## SERVICE BULLETIN ASM-011

Product: Antenna System Monitor

Subject: Firmware 2.50 Release

**SAM Module Alarm Output Sources**

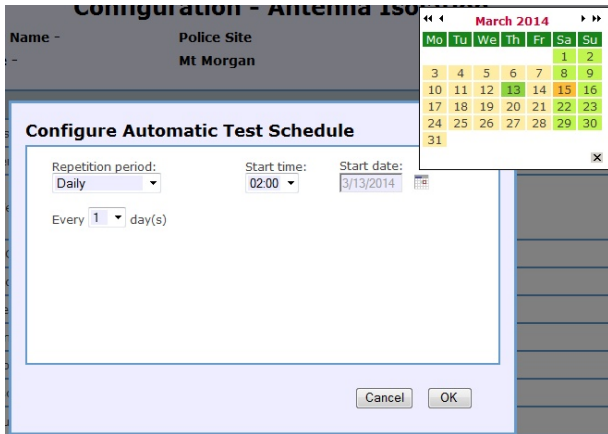
- vii) Antenna Isolation and Rx Level are now alarm source selections that can be assigned to the 4 summary alarm outputs on the ASM, and CAM/SAM module's alarm outputs.

Configure – Alarm Settings – System screen extract showing the ASM's four alarm relays

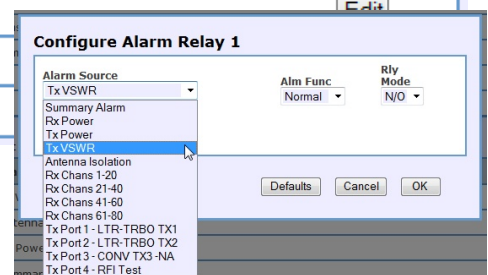
- x) The four (4) summary alarm relay outputs on the ASM can now be mapped to any of the available alarm sources – the ASM Antenna Isolation, Rx Level, Tx Level or Tx VSWR, and they may also be mapped to CAM/SAM modules External or Digital inputs if these optional modules are connected.

This new feature allows the ASM's four alarm relays to be mapped to other alarm sources than the previously available 'summary' alarm conditions, and allows some functionality to be achieved by the ASM directly without the use of the optional CAM/ASM modules. An example of this may be to map Tx VSWR alarms to one of the ASM alarm relay outputs to control an Antenna Change-Over (ACO) coaxial relay – allowing a standby Tx antenna to be automatically selected if the main Tx antenna failed.
